## Housing Authority of the City of Pittsburgh

### **Arch Street Duplex Renovation AMP-39 IFB #600-40-24**

#### **ADDENDUM NO. 1**

**Photo 1.** Missing Stair Base Attachment

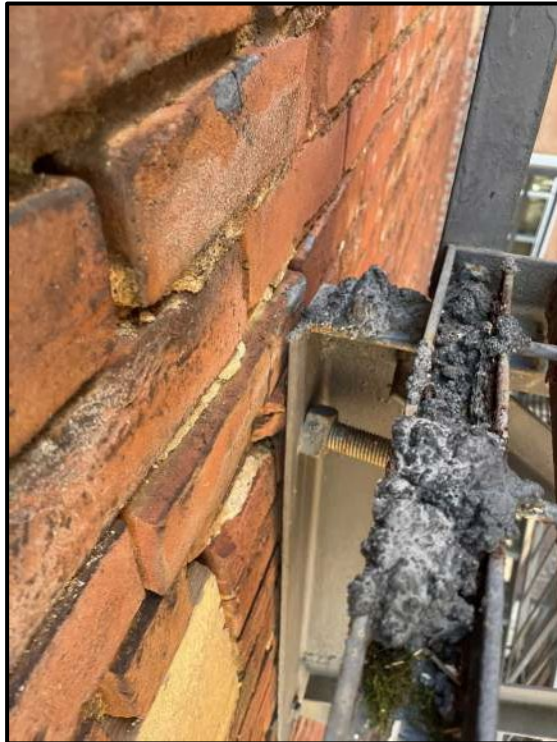
1. Providence observed steel angles welded to the base of the lowest stair stringer that had missing anchor bolts. Providence recommends adding mechanical anchors to fix the base of the stair stringer to the concrete landing similar to Hilti Kwik Bolt 3.
2. Portions of the metal grating and steel pieces had minor corrosion and peeled paint. Providence recommends cleaning the exposed steel and painting the steel with a corrosion inhibitor primer.

- 1) The steel angles welded to the base of the lowest stair stringer had missing anchor bolts. Install mechanical anchors at the base of the stair stringer to the concrete landing equal to Hilti Kwik Bolt 3
- 2) Portions of the metal grating and steel pieces had minor corrosion and peeled paint. Clean the exposed steel and paint the steel with a corrosion inhibitor primer, followed by painting of the entire fire escape. (**Attachment A**)

**Photo 1.** Missing Stair Base Attachment

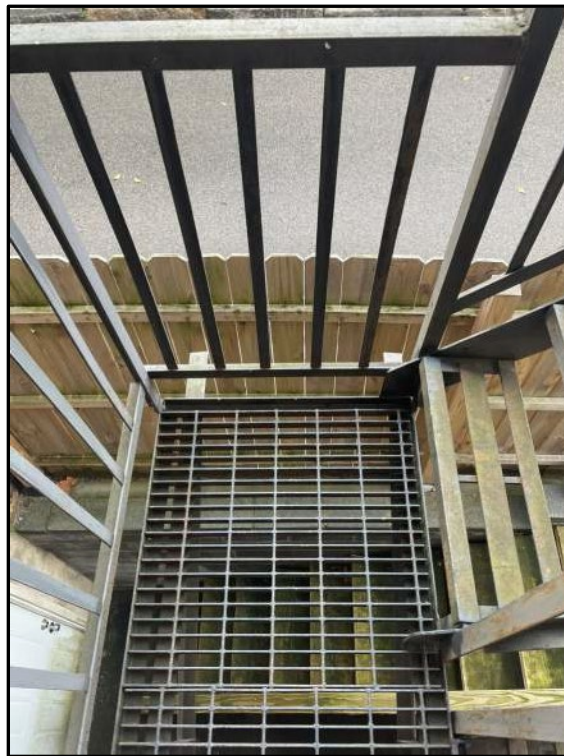
1. Providence observed the stair stringers at the base with no attachment to the slab on grade. The base of the stairs was loose and did not have steel angles welded for anchor bolts. Providence recommends adding a L3x3x5/16x 0'-4" angle with mechanical anchors to fix the base of each stair stringer to the concrete landing. Approved anchors shall be similar to Hilti Kwik Bolt 3.
2. Portions of the metal grating and steel pieces had minor corrosion and peeled paint. Providence recommends cleaning the exposed steel and painting the steel with a corrosion inhibitor primer.

- 1) The stair stringers at the base have no attachment to the slab on grade. The base of the stairs is loose and does not have steel angles welded for anchor bolts. Weld a L3 x 3 x 5/16 x 0'-4" angle with mechanical anchors to the base of each stair stringer to the concrete landing. Install anchors equal to Hilti Kwik Bolt 3.
- 2) Portions of the metal grating and steel pieces had minor corrosion and peeled paint. Clean the exposed steel and paint the steel with a corrosion inhibitor primer, followed by painting of the entire fire escape. (**Attachment B**)
